Empanelment of vendors for Design, Supply, Erection, Testing and Commissioning including warranty, comprehensive Operation & Maintenance of grid-connected rooftop solar plant of various capacities under Phase-II of GCRTS Scheme of MNRE being implemented in the State of Odisha

Replies to Pre Bid Queries

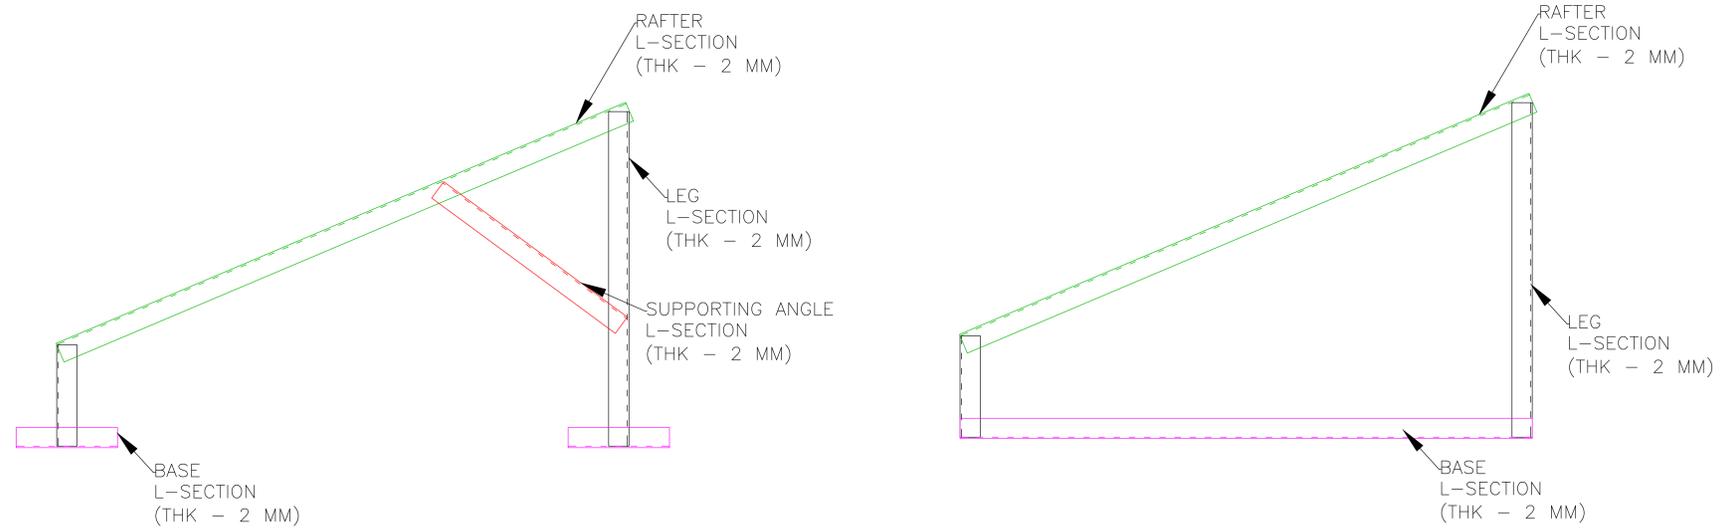
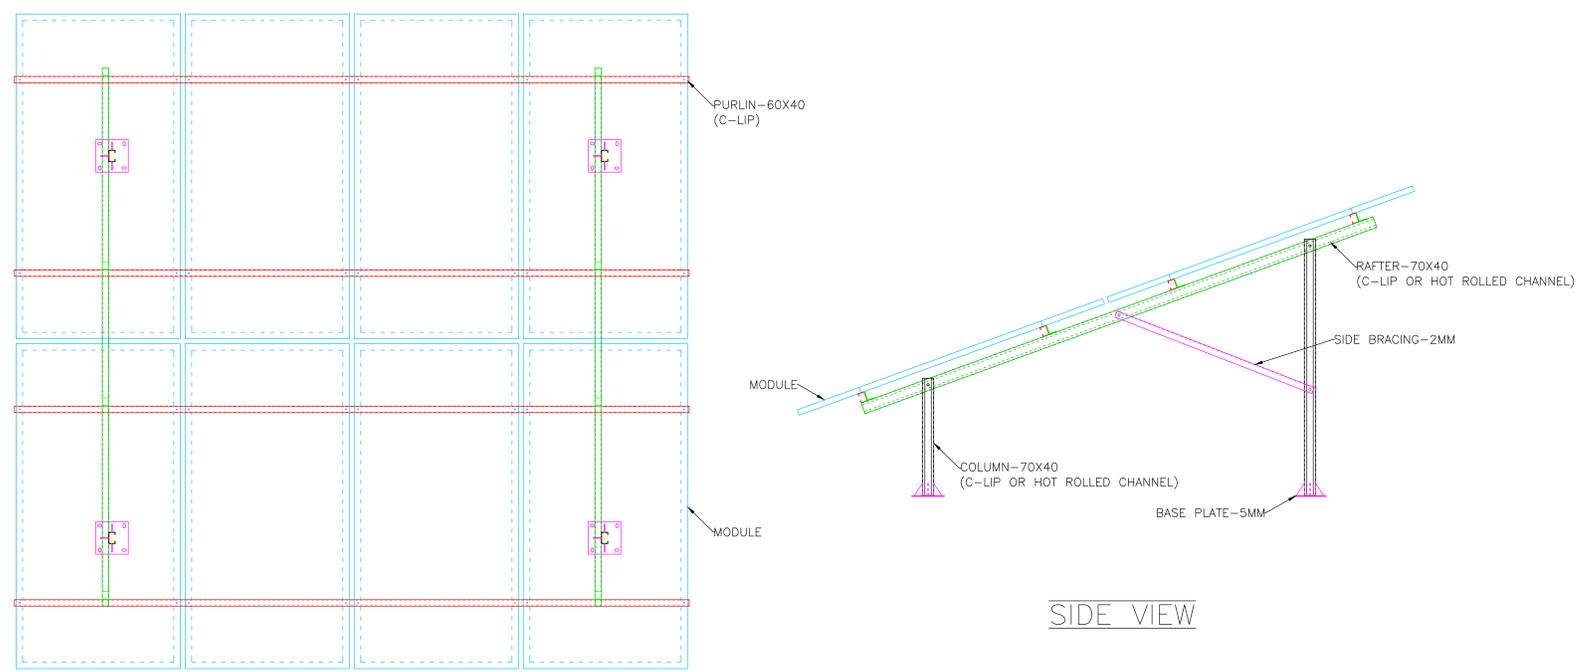
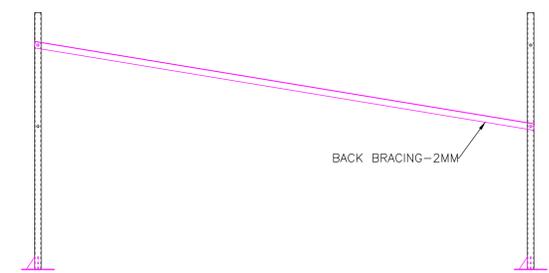
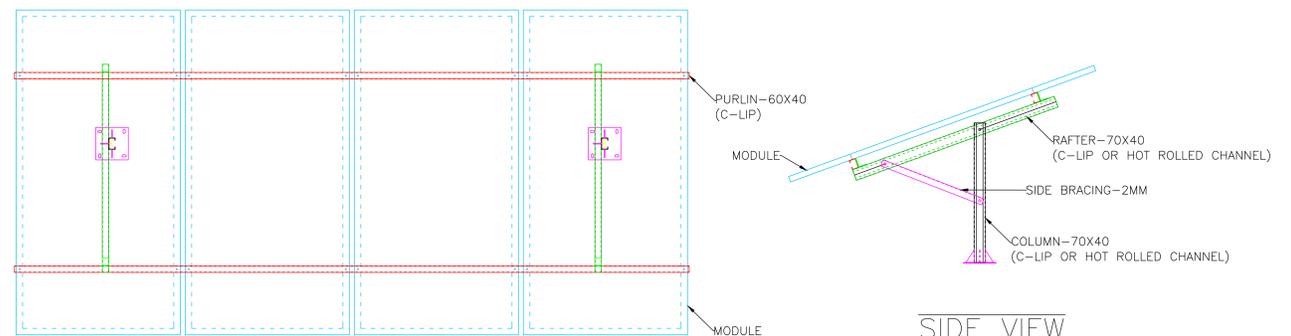
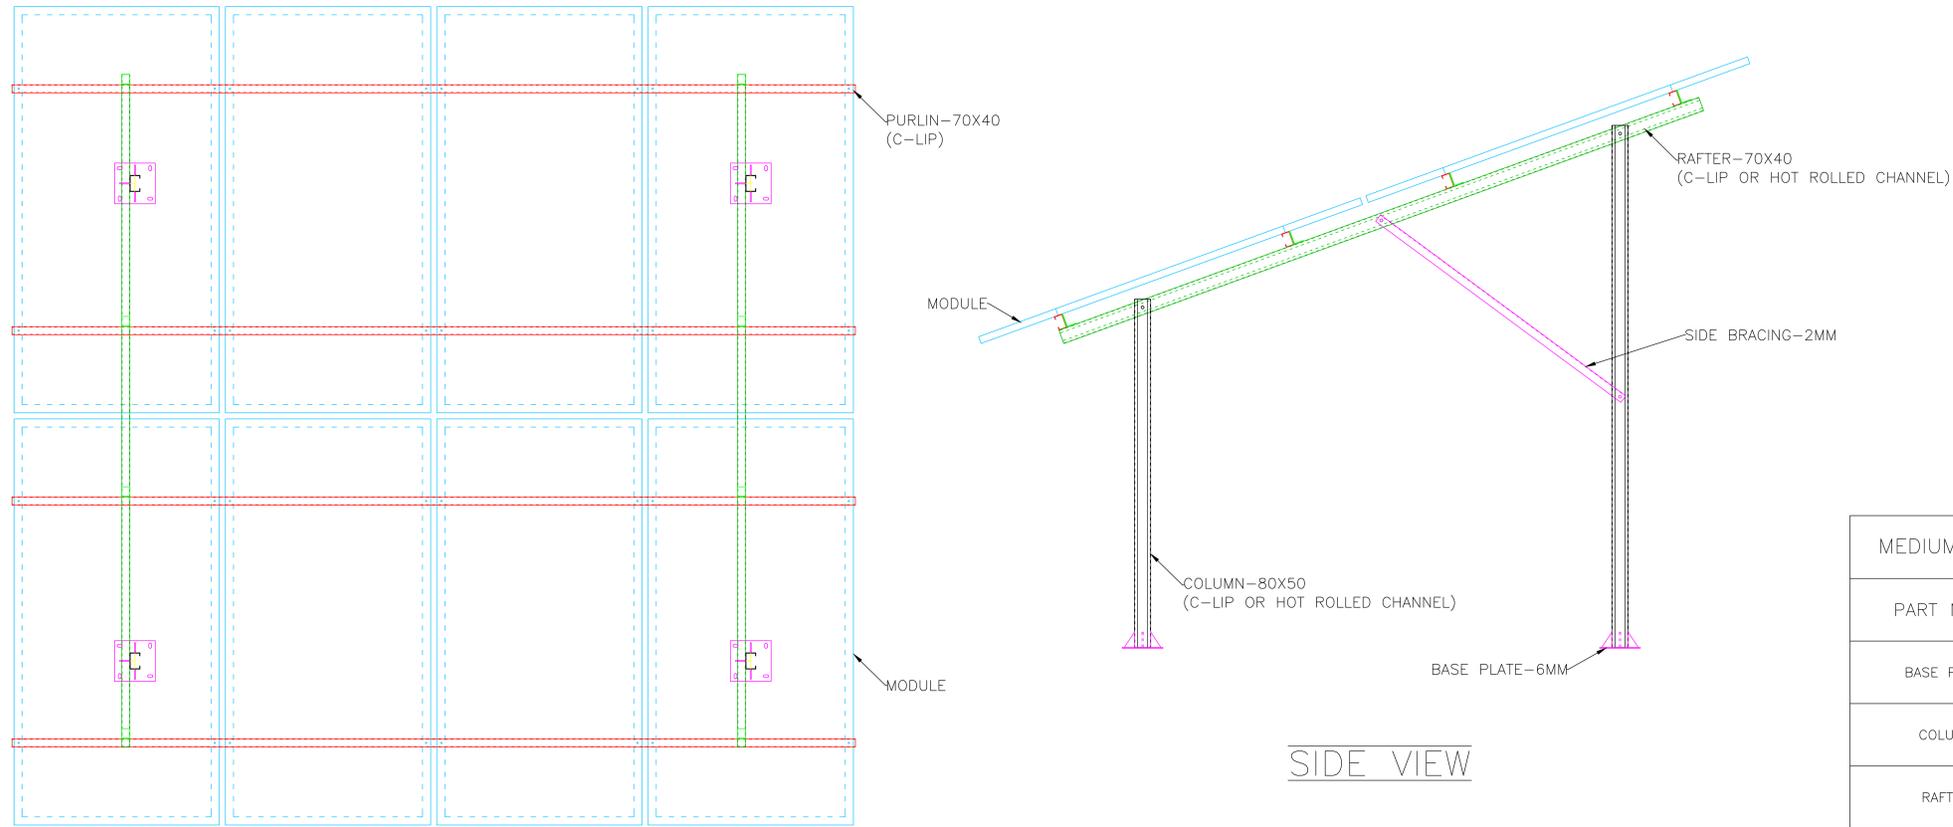
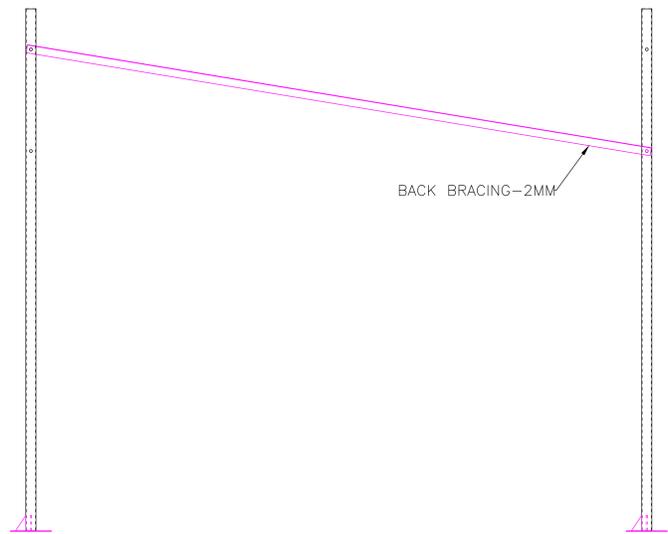
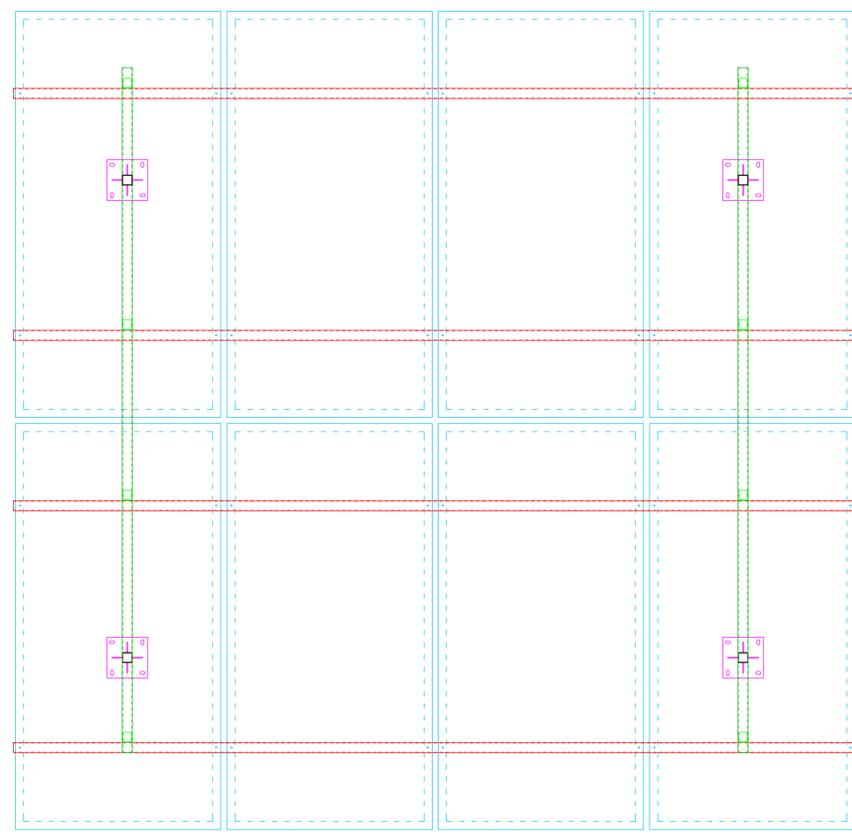
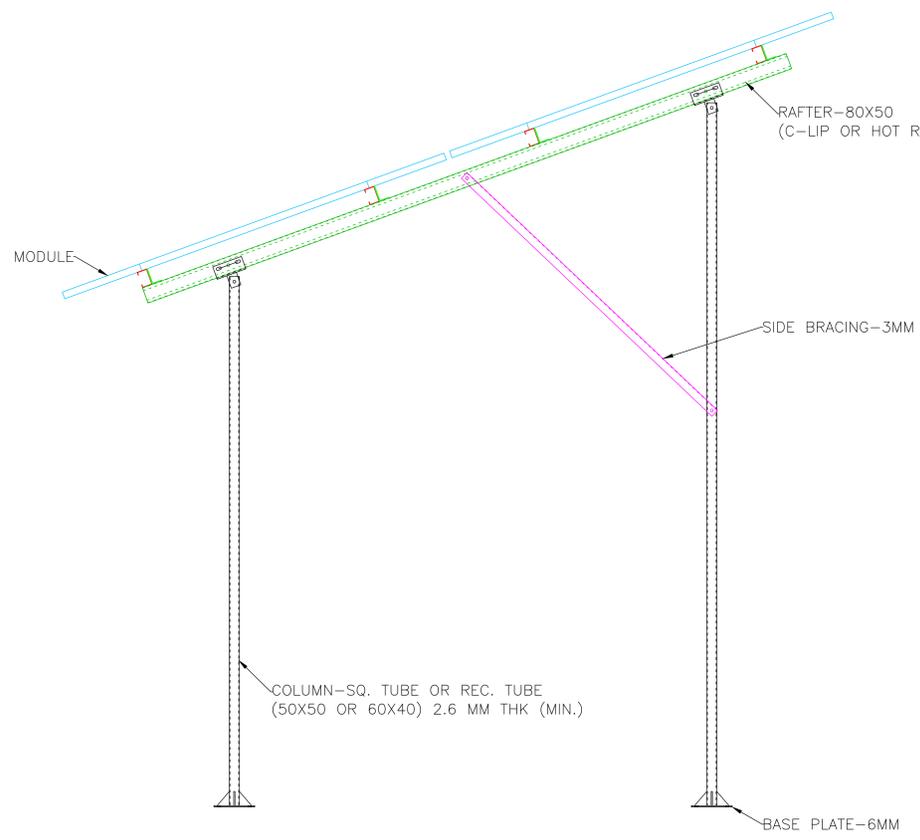
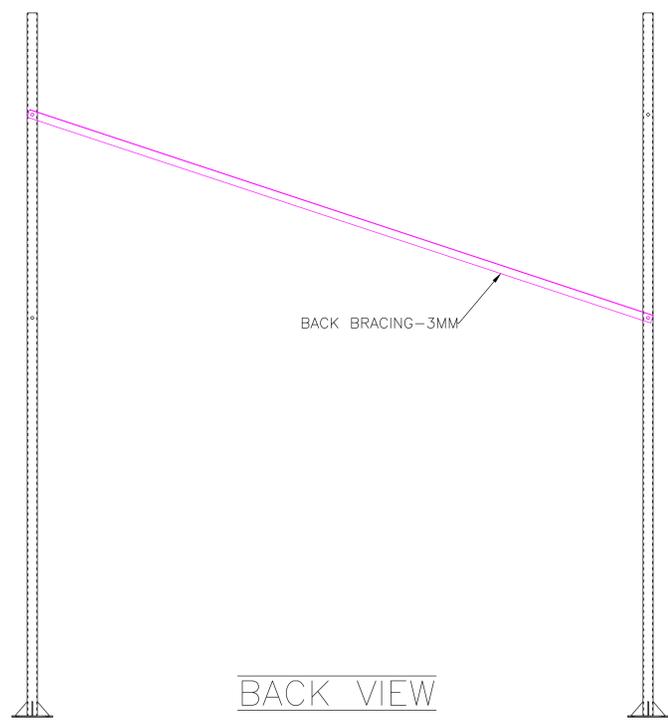
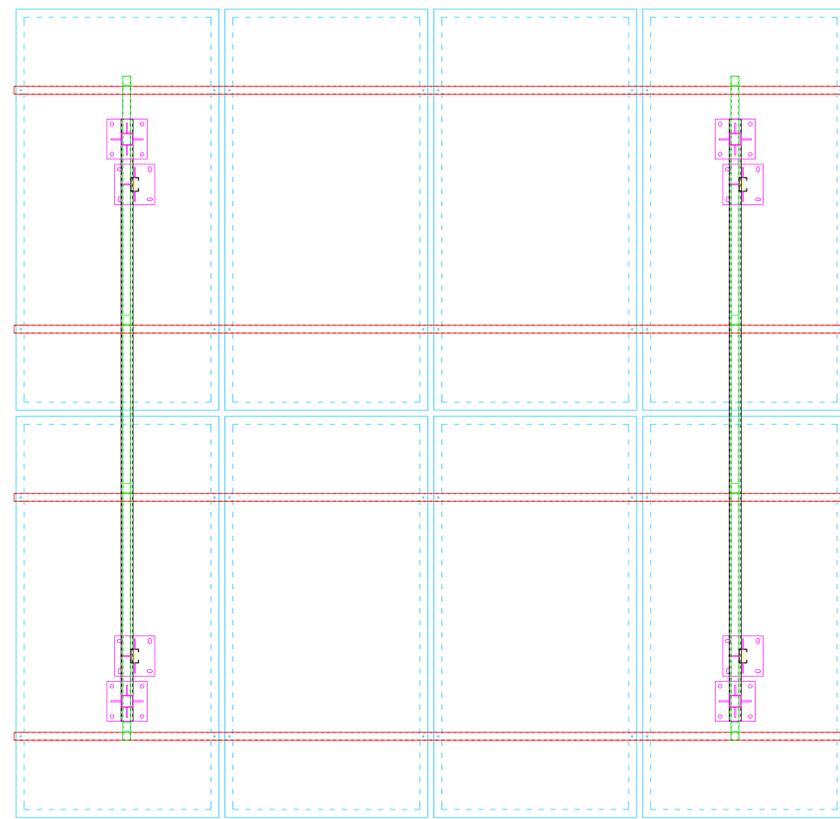
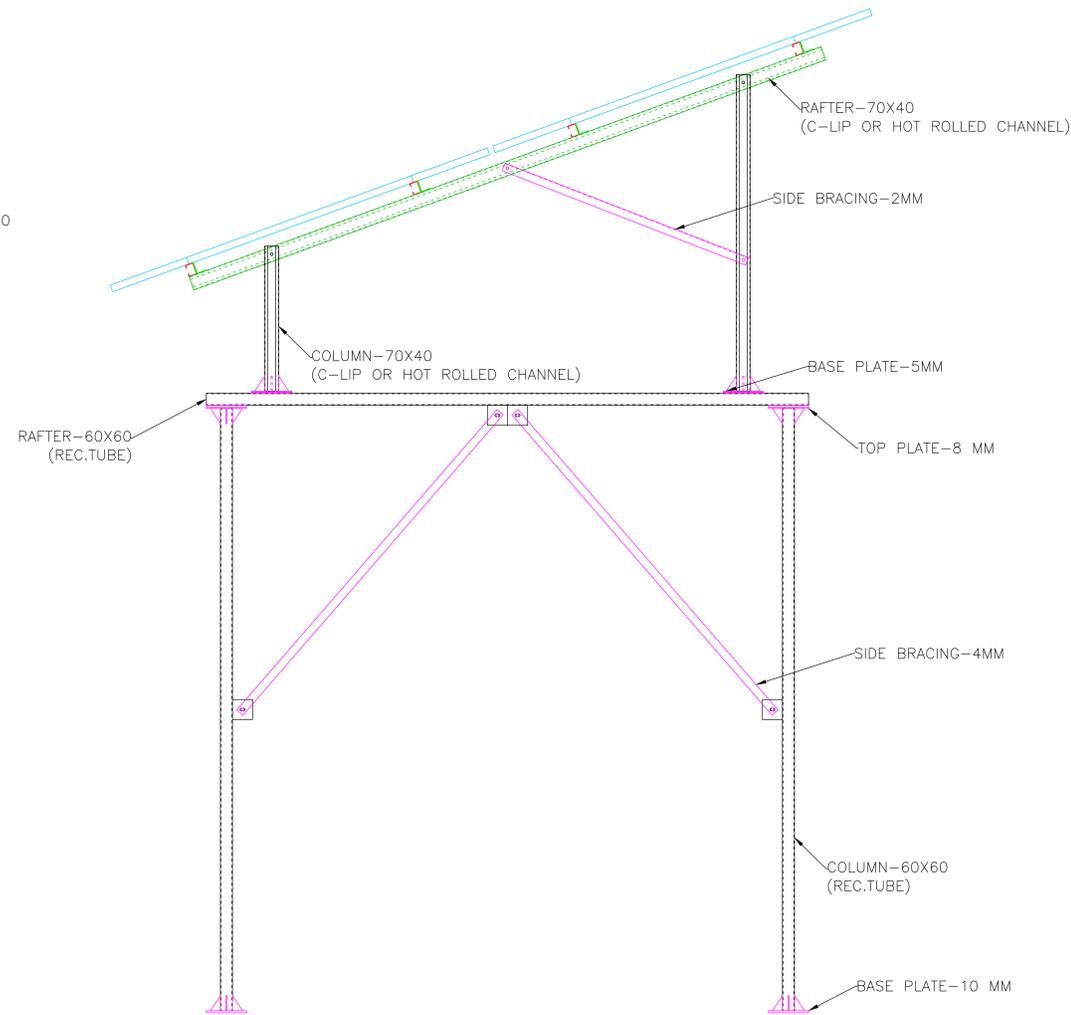
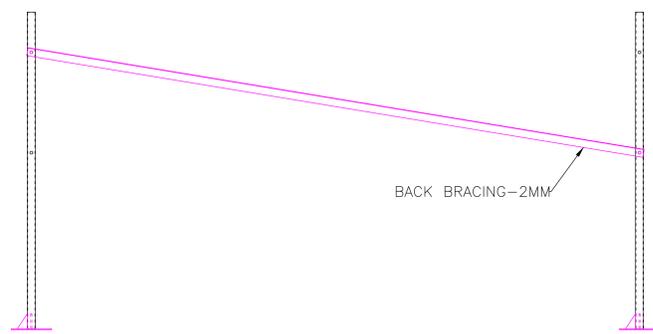
30					As discussed in the meeting New structural drawing is to be released. Kindly share the updated drawing.	Drawing attached
31					Do we need individual 100KW experience in each part. E.g. If we want to quote for TPNODL Part D, Part E and Part F. Do we need a total of 300KW experience or with only 100KW experience we will be able to participate in all parts.	Bidder may bid for any part in any discom. The minimum experience shall be as per RFP terms i.e. 100KW.
